La Marzocco Technical Bulletin #146

Modified Flow Meter Sensor

May 25, 2018

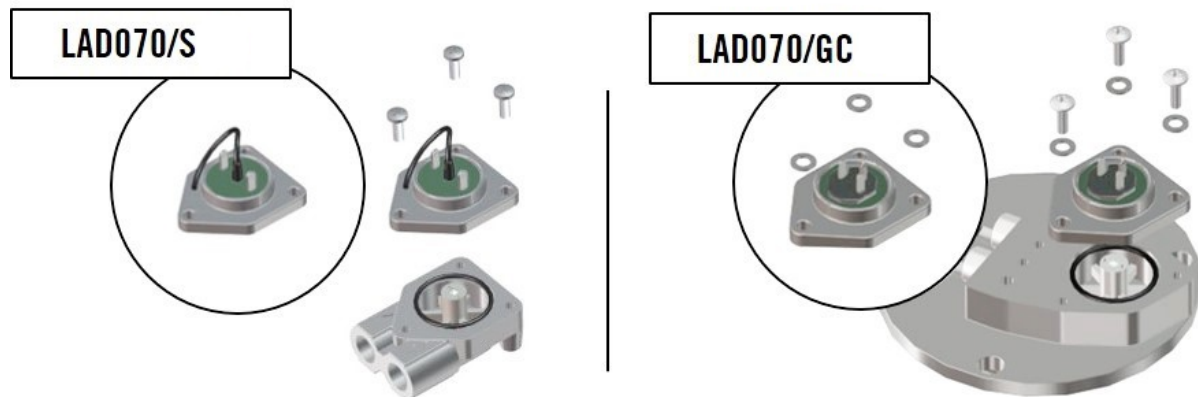
The flow meter field sensors have been modified. The new parts are slightly thinner than the previous versions and are functionally the same. The part numbers will remain the same.

Due to the new flow meter field sensor being thinner, the LAD070/GC will come with three washers. This will allow installation of the LAD070/GC using the same screws. This does not apply to the LAD070/S as the screw holes are long enough to accommodate the screws with the thinner flow meter field sensor.
